BOARD OF SUPERVISORS

ITEM # 8

Owner: **Anusha Thalapaneni and David Jackson**
Appellant: **Denise Enea, Terry Irwin, Jim Goodrich, Mary Lassiter,
Josh Miller, Yuriy Makarov, & Kathy Fagliano**
File Number: **PLN 2020-00251**
Location: **634 Palomar Drive, Palomar Park**
APN: **APN 051-022-380**
Project Description:
Construction of a three-story, 4,249 sq. ft. single-family residence, 315 sq. ft. covered terrace, a 155 sq. ft. deck, and a 554 sq. ft. attached garage, on a 18,122 sq. ft. legal parcel.

(E) SITE PLAN / TREE PROTECTION MEASURES

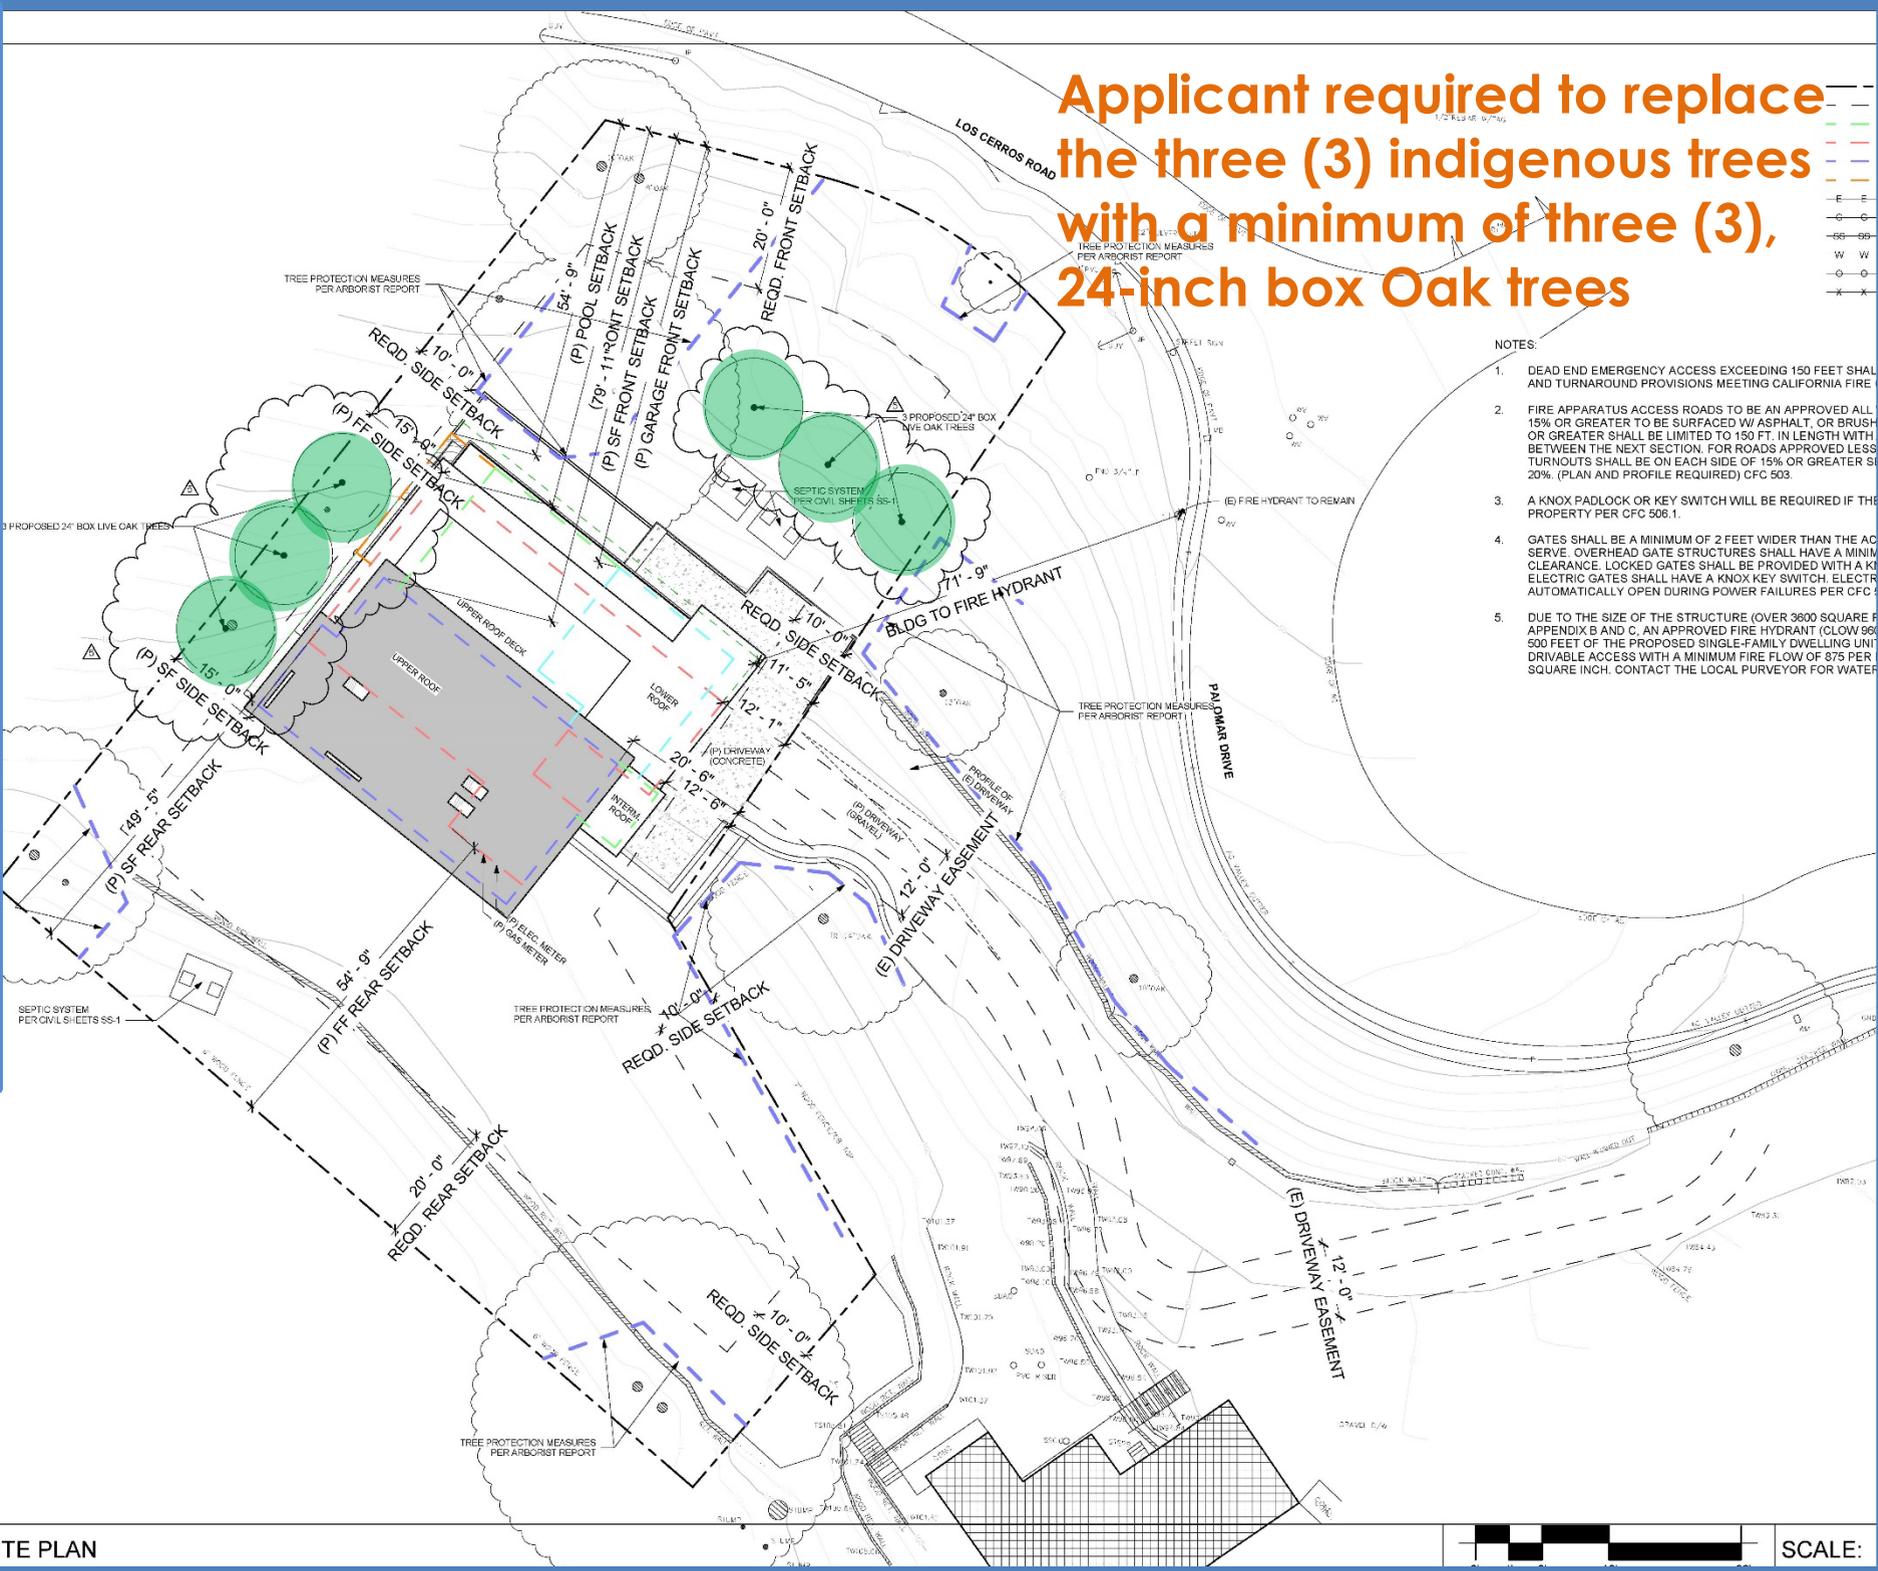
Removal of 2 significant trees (21"/17.5" Coast Live Oak and 10/6.4" Buckeye) and a 5.14-inch California bay tree

Applicant required to replace the three (3) indigenous trees with a minimum of three (3), 24-inch box Oak trees
